## City of Lewisville, TX Agenda

### Joint Meeting of the Planning and Zoning Commission and Transportation Board

**Tuesday August 4, 2020**

**SUBJECT: Development Plan/Preliminary Plat of Lewisville Corporate Center Addition, Lot 2, Block A; on 6.641 Acres out of the Steven Riggs Survey, Abstract Number 1088; Zoned Planned Development – Mixed Use (PD-MU) District; Located on the West Side of State Highway 35 East (I-35E), Approximately 850 Feet South of Justin Road (F.M. 407), Being a Replat of Lot 2, Block A, Lewisville Corporate Center Addition.**

DEVELOPMENT PLAN 1

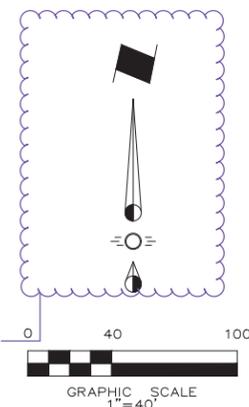
Drive through here forces counterflow of traffic and dangerous condition. Please revise to eliminate stacking contrary to vehicle flow.

Need building sq ft to confirm compliance. Only see about 47,000 SF. Concept shows larger longer buildings. Minimum based on residential ground floor SF within 350' of highway and is approximately 55,000. Provide ground floor SF for residential v. commercial numbers within 350' of IH-35E ROW per Ordinance 4225-11-2015 page P-3.

Per PD Ordinance 4225-11-2015 submittal needs to include everything per Preliminary Plat checklist in section 6-73. Per 6-73 provide: Title Block per code appendix; location map (city base map with 1"-1,000' scale; Abstracts and surveys of subject property; abstract and survey lines; boundary line (accurate in scale); lot numbers and block numbers for each lot; zoning of subject and adjacent property; setbacks from lot lines and easements; dimensions of lots and blocks, contours of 2' or less; names of adjacent subdivision or record owners of property; cross section of proposed streets (including private streets - NRP provided as well; Traffic control devices and striping including parking spaces); easements, deed restrictions or other encumbrances; control of access lines, corner clips and clear vision areas, phase lines must be clearly delineated with improvements capable of standing along and meeting all city requirements at each phase; City signature block (per appendix); name, address and phone number of developer, owner and engineer/surveyor; sheet size of 22" by 24". Please insure all information correct, consistent and clear.

development plans must show and currently does not show:  
 pedestrian connections  
 water and sewer  
 drainage  
 per Ordinance 4225-11-2015

<b>DEVELOPMENT PLAN 2</b>	Sheet No. <b>DP2</b>
Lewisville Corporate Center	
Beverly Development Corp.	
Lewisville, Texas	
Project No. 20043

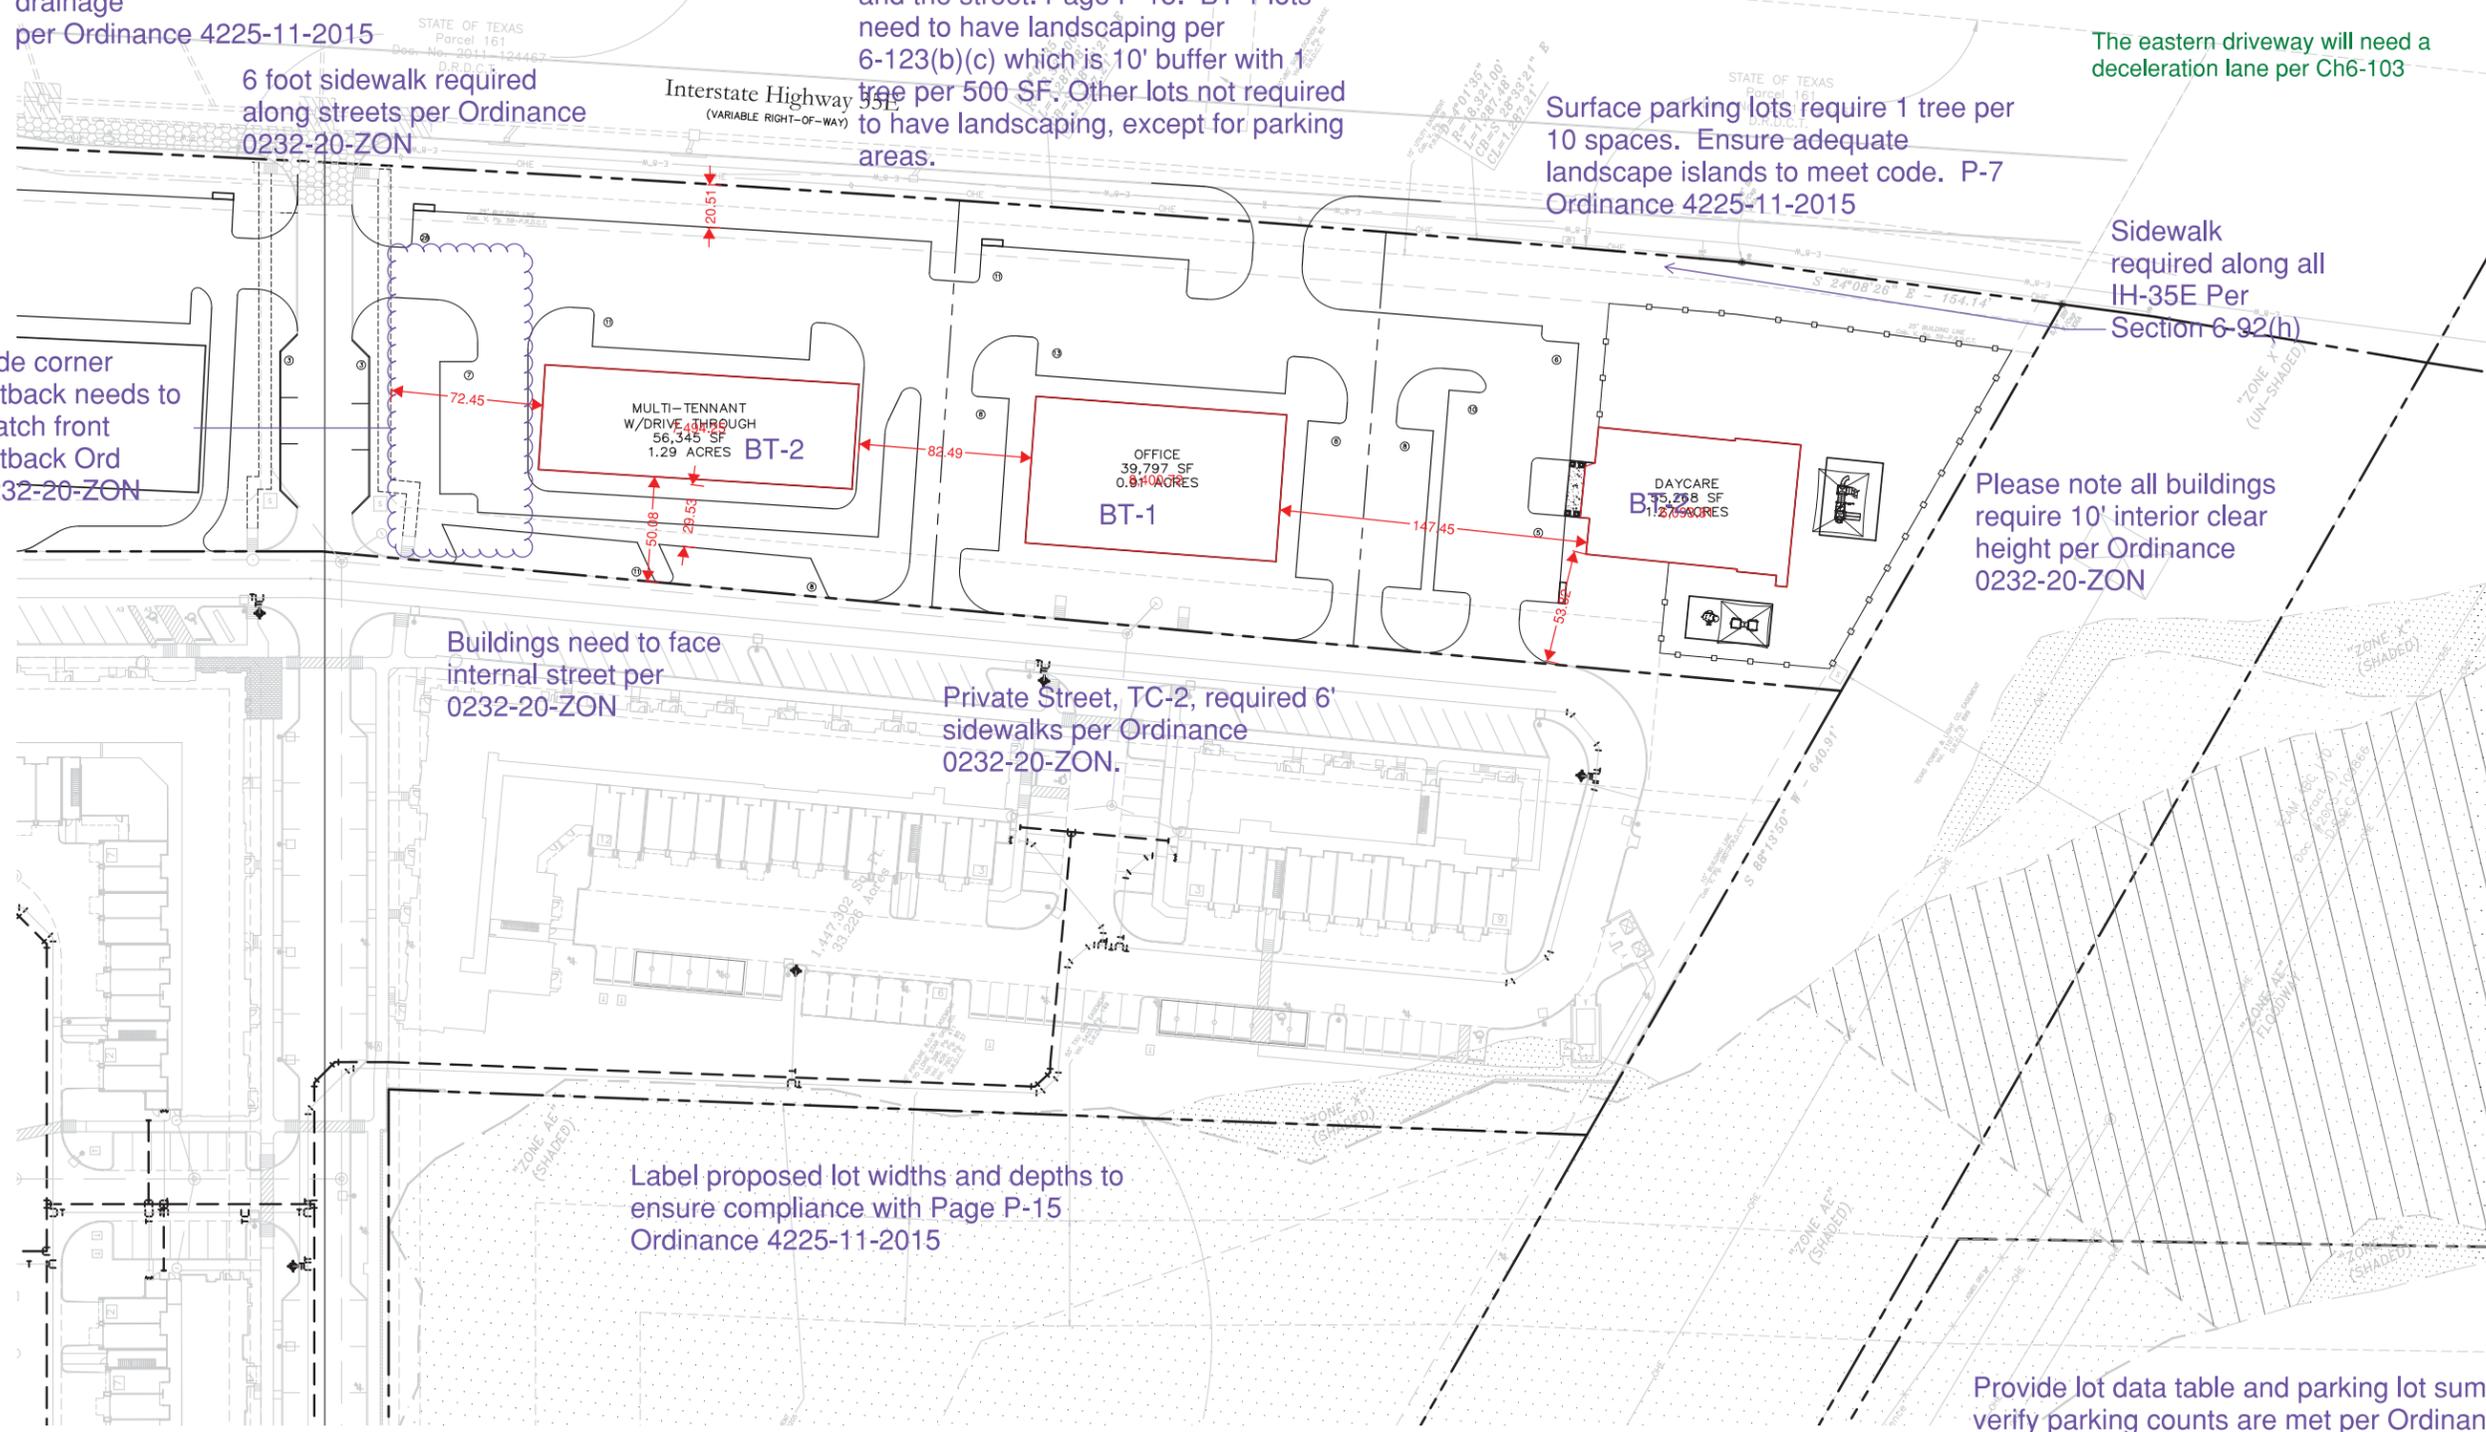
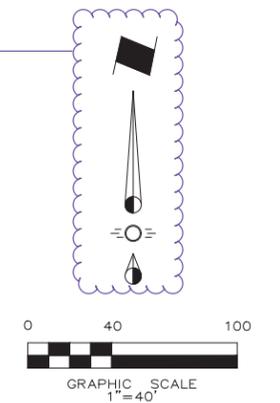
Sidewalk required along all IH-35E Per Section 6-92(h)

Side corner setback needs to match front setback Ord 0232-20-ZON

Please note all buildings require 10' interior clear height per Ordinance 0232-20-ZON

Buildings need to face internal street per 0232-20-ZON

Provide lot data table and parking lot summary to verify parking counts are met per Ordinance 0232-20-ZON Show parking lot stripes on plans.

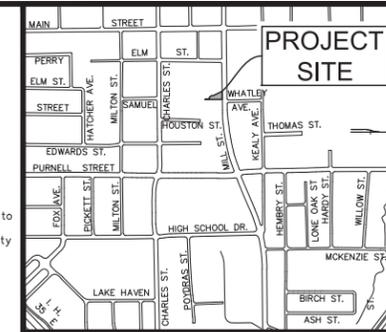
Remove as not consistent with OTMU2 zoning, Sec 17-22.7

No need to show rear setbacks, remove, Sec. 9.5-71 (f)

Sheet size must be 22" by 34" for inclusion with ESP Sec. 9.5-71 (f). Can print with border for filing.

revise note to specify park fees:  
Park development fee is \$1,000/unit = \$6,000  
Park dedication fee in lieu is 0.03(acres) x 6(units) x \$152,611 = \$27,469.98

use requires OTMU2 zoning, please submit zone change for Owens tract, Sec 17-22.7

**FINAL PLAT**  
**CASTLE HILLS - GOLF VILLAS PHASE III**  
2.171 TOTAL ACRES  
19 TOTAL LOTS

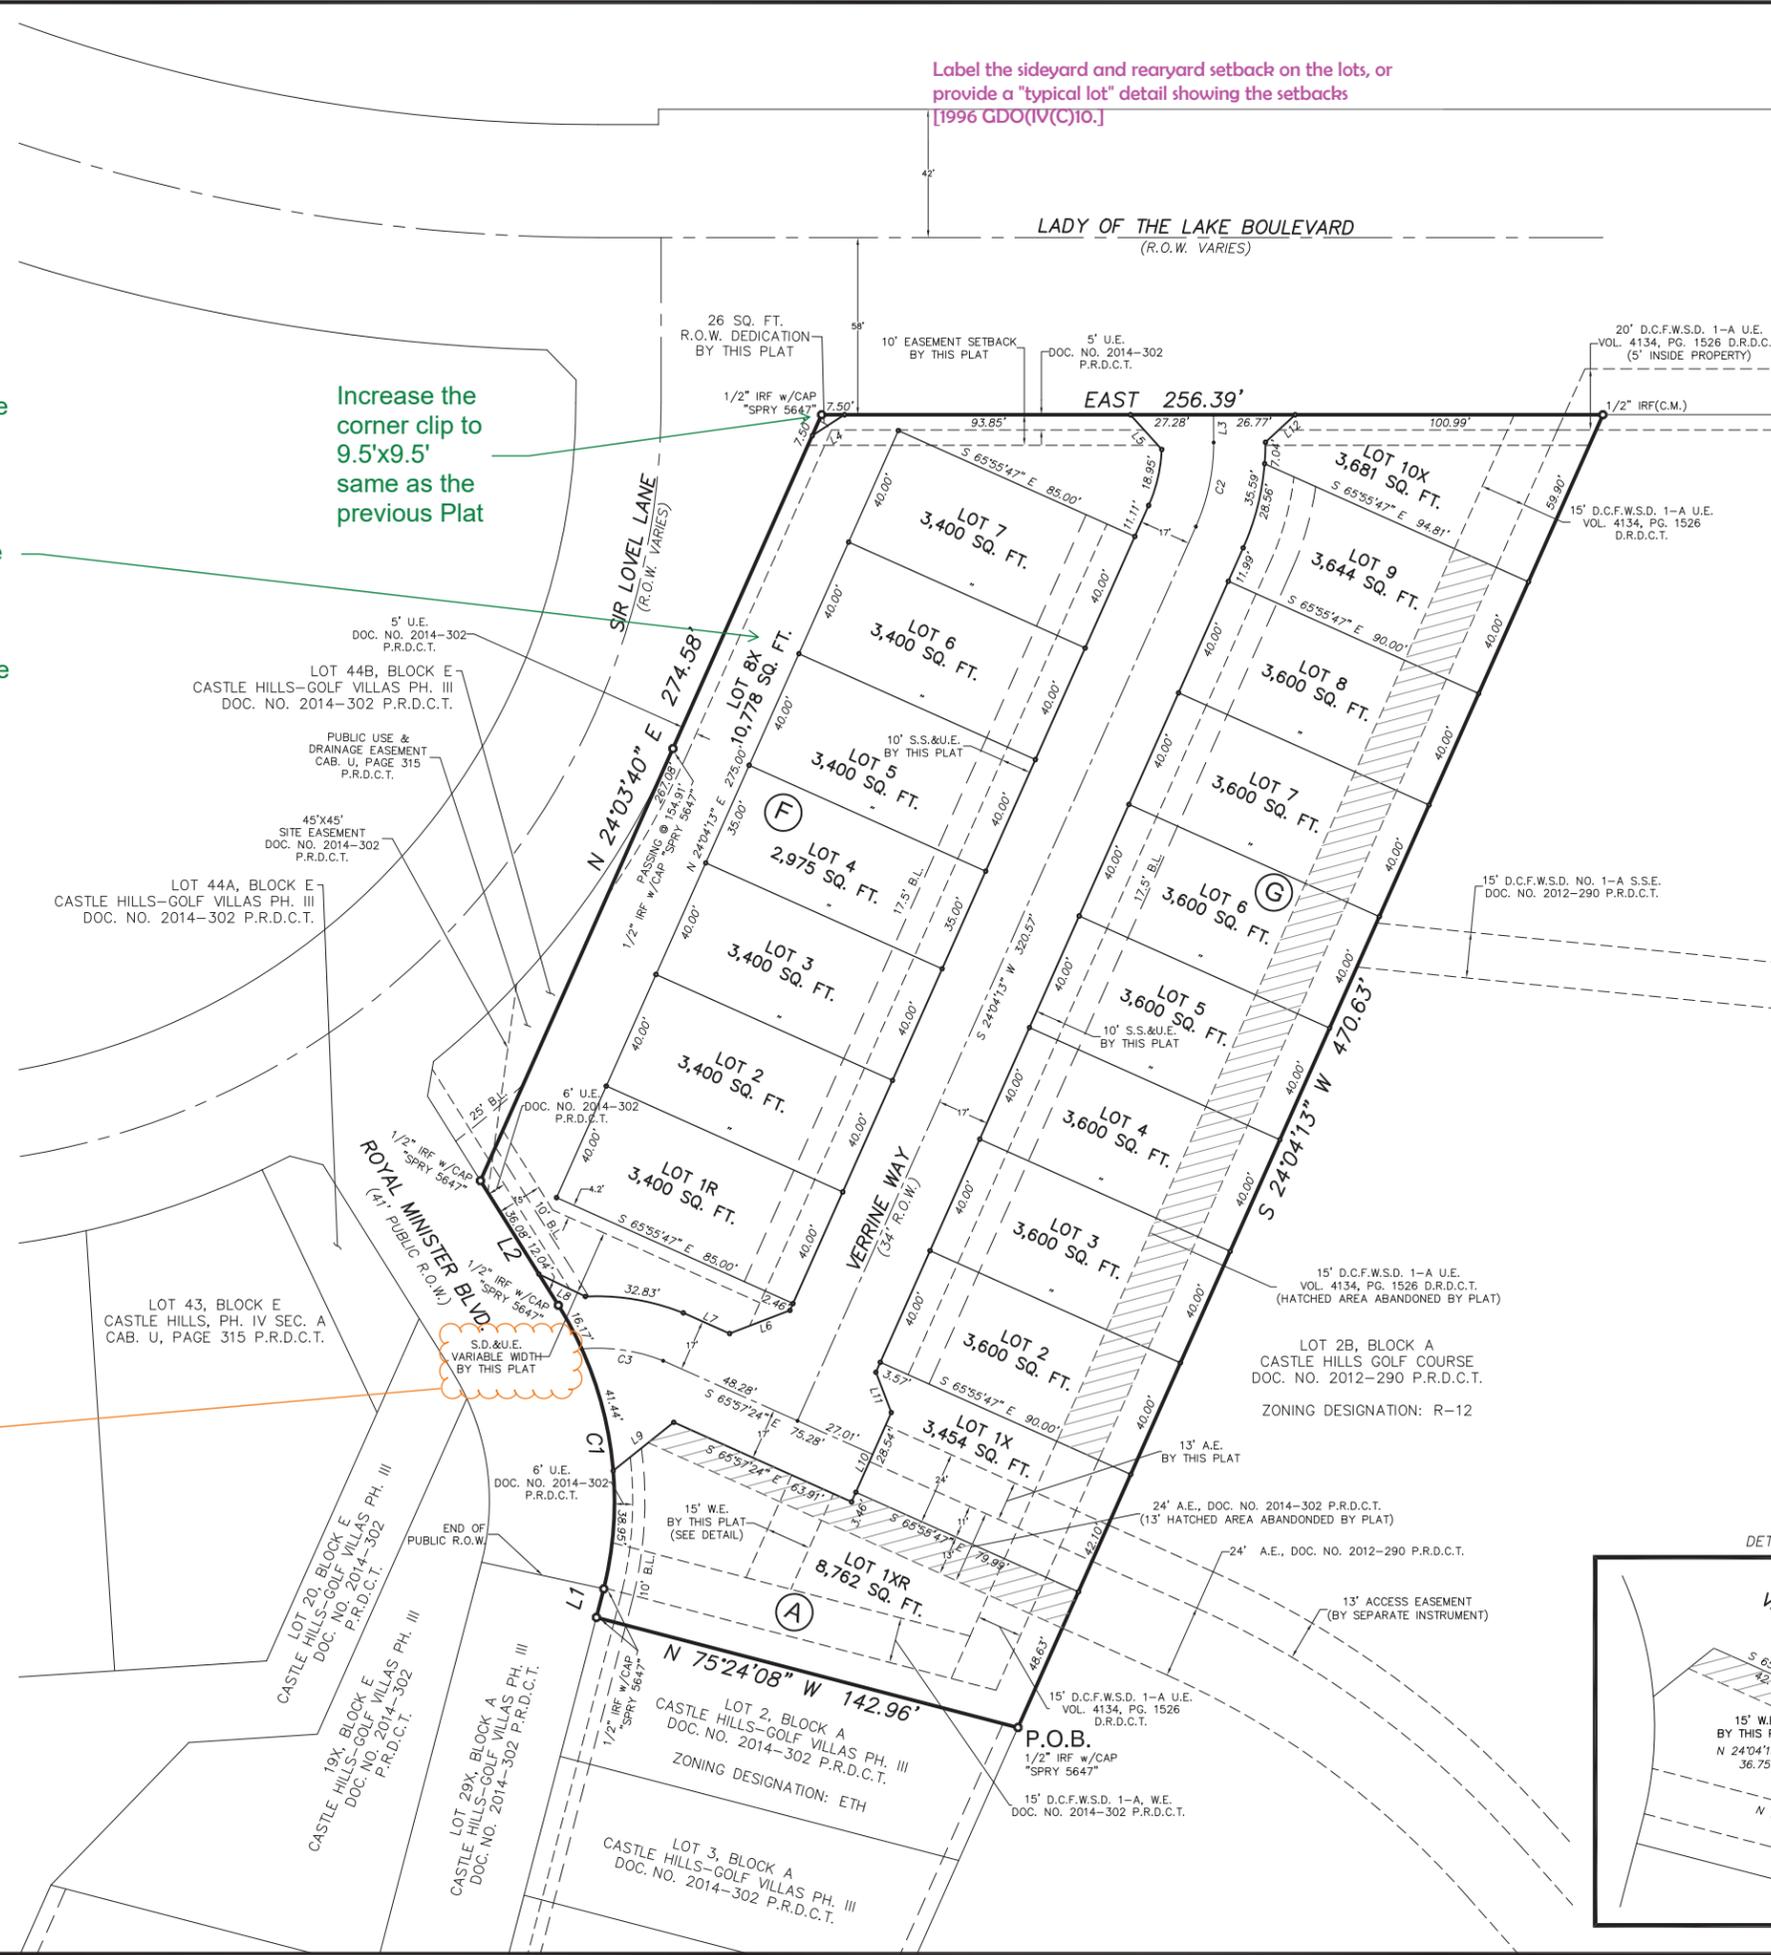
Please provide a variance letter and variance exhibit  
 with the next submittal

Label the sideyard and rearward setback on the lots, or provide a "typical lot" detail showing the setbacks [1996 GDO(IV)(C)10.]

Include the note from the last Plat that this is a private drainage easement to be maintained by the HOA. Also label as a private drainage easement

Please only use one zoning designation for this plat.
